PLANNING REPORT

PLANNING AND ZONING COMMISSION

**5. Shoppes at Athenry Outparcel
07-029AFDP**

**7090 Muirfield Drive
Amended Final Development Plan**

PROPOSED LANDSCAPE PLAN

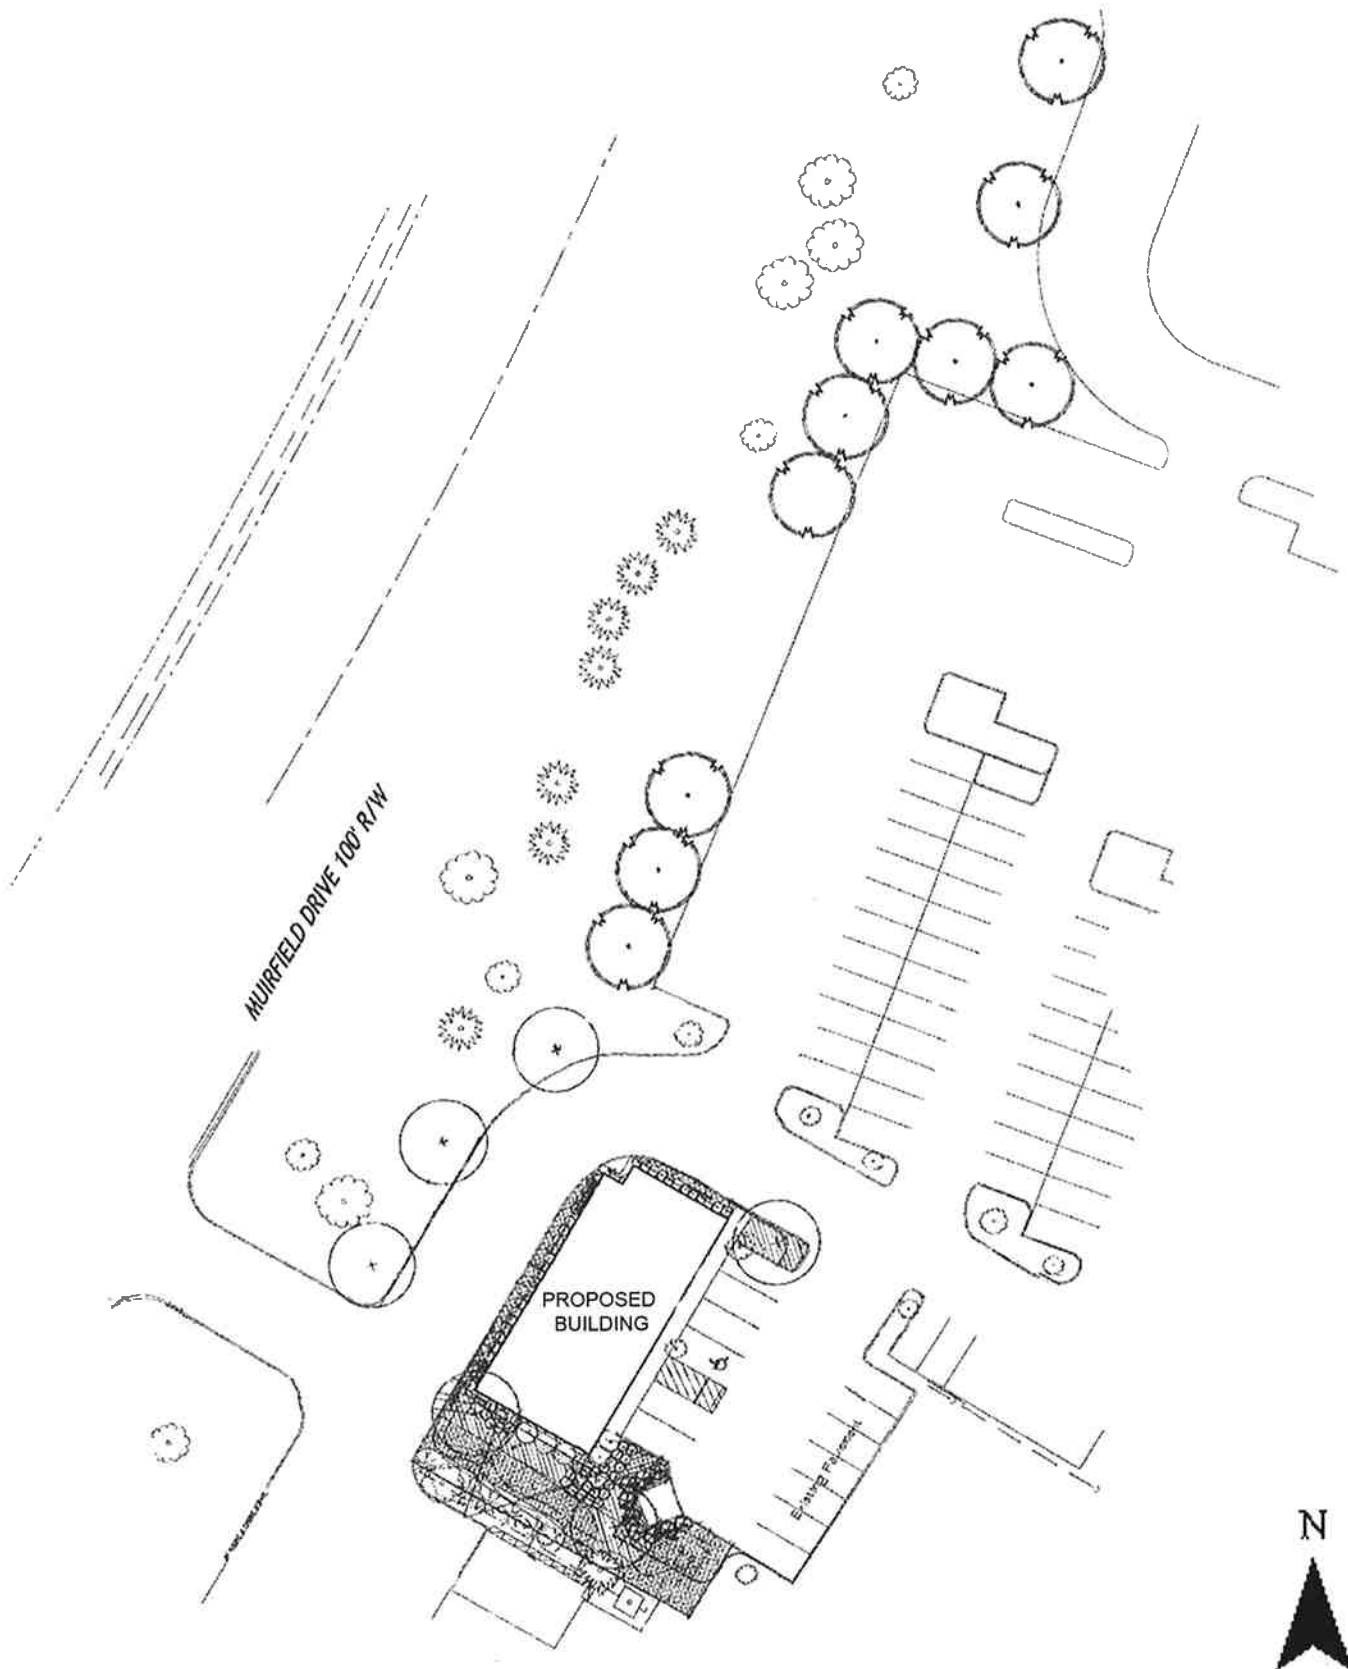
Tree replacement is required to equal or exceed the combined diameter for protected trees that will be removed with a project. This proposed building and site will impact 28 caliper inches of existing trees. The plans show replacement trees totaling 30 caliper inches (ten trees at three caliper inches each) but do not reflect the recommended spacing accurately.

Criteria met through conditions. The plans include appropriate landscaping and the proposed signs meet the development text. The landscape plans should be revised to show the replacement trees located at the recommended 40-foot on center spacing between trees along the western edge of the parcel (Condition #2).

- 1) That the proposed plans are to be revised to reflect the installation of a vehicle return located adjacent to the proposed dumpster to ensure proper parking maneuverability; and
- 2) That the landscape plans be revised to show the replacement trees located at the recommended 40 feet on center spacing between trees along the western edge of the parcel.

PROPOSED ELEVATIONS

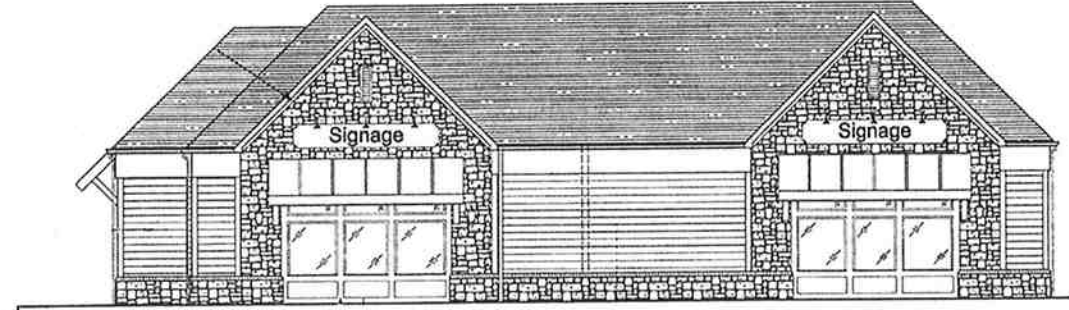
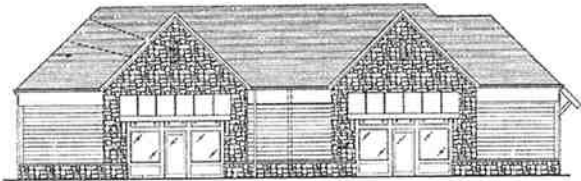
The approved text requires four-sided architectural design that coordinates with the residential character of the area. The proposed building architecture is similar in style to the existing Shoppes at Athenry. The building incorporates a hipped roof and two cross gables with store front windows on the east and west elevations. The exterior elevation plan shall be revised to show the correct scale for building elevations.
